Subject: AP1000 Response to Request for Additional Information (SRP 10)

RAI-SRP10.2-SBPA-02 R2

RAI Response Number: RAI-SRP10.2-SBPA-02

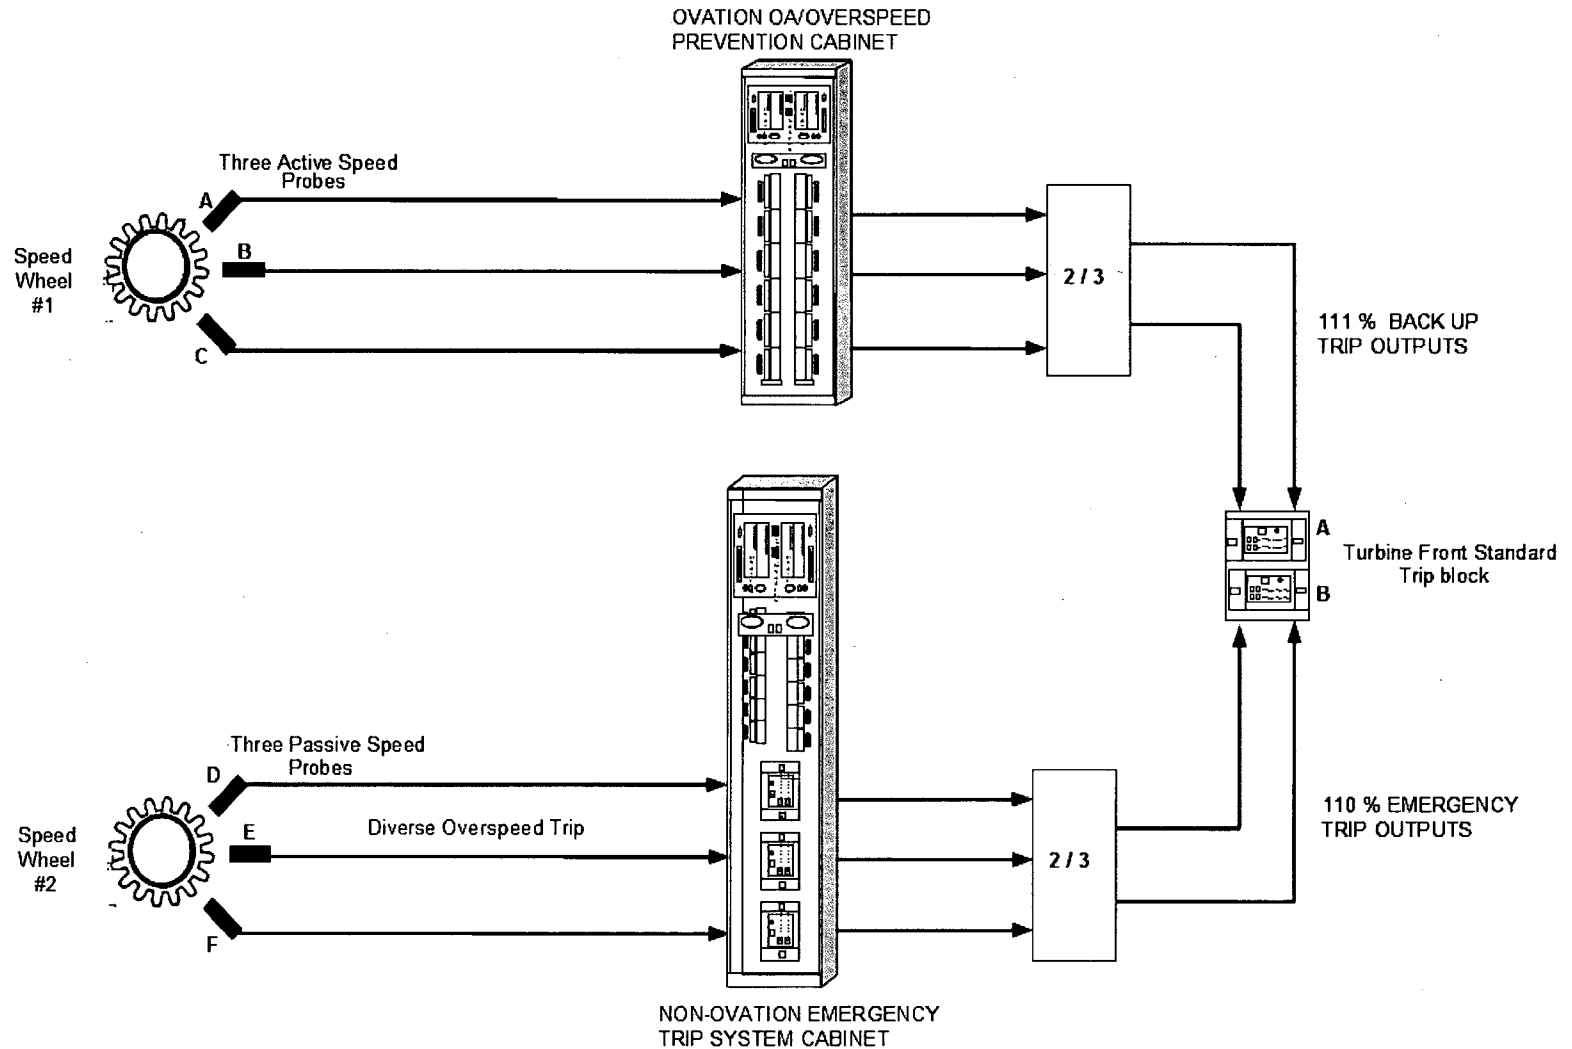
In addition, as a result of a conference call with the NRC on July 23, 2009, Westinghouse is proposing clarifications be made to Tier 2 DCD subsections 10.2.2.4.1, 10.2.2.4.5, and 10.2.2.5.3. Westinghouse stated in the conference call that both the 110% and 111% overspeed trip systems are not contained in a single controller and that one of the trips is contained in a non-Ovation controller. The commitment to separate these trips into separate, diverse controllers was made after DCD Revision 17 was issued in response to the staff's initial submittal of this RAI.

The DCD changes proposed below show and clarify that the 110% and 111% trip systems have diverse hardware and software/firmware to eliminate common cause failures (CCFs) from rendering the trip functions inoperable. A diagram is provided below to show the system configuration with a non-Ovation controller for the diverse 110% emergency trip system.
